COTTONWOOD HEIGHTS PLANNING COMMISSION MEETING AGENDA

Planning Commission Staff Report
MEETING DATE: April 20, 2016

FILE NUMBER/
PROJECT NAME: SP-16-001; Willow Creek Pet Center Program for Signs

FILE NUMBER/
PROJECT NAME: **CUP-16-005 COTTONWOOD DENTAL S.P.A.**

SHEET TITLE
LANDSCAPE PLAN AND SIGNAGE

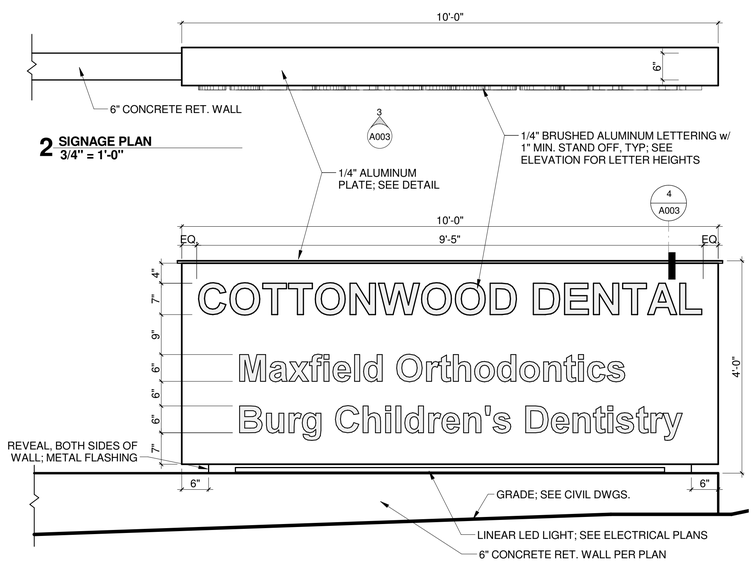
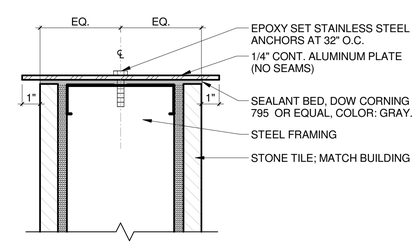
- Applicant shall provide additional trees on the site, specifically towards the front of the building.
- Because there is a lot of PENNISETUM ALOPECUROIDES around the north and east side of the building, accents shall be added to that planting.
- Applicant shall organize the plantings into either strong architectural patterns or in massings.
- A color and material sample board shall be provided.
- Staff can coordinate ARC acceptance of the conditional changes to the landscaping plan via email correspondence.

Analysis: The proposed plan and layout of the project has been reviewed and approved by the ARC. The applicant submitted updated plans incorporating the conditions of the ARC as well as a color and material sample board and those updated plans and color board were accepted by the ARC. The project has received a Certificate of Design Compliance.
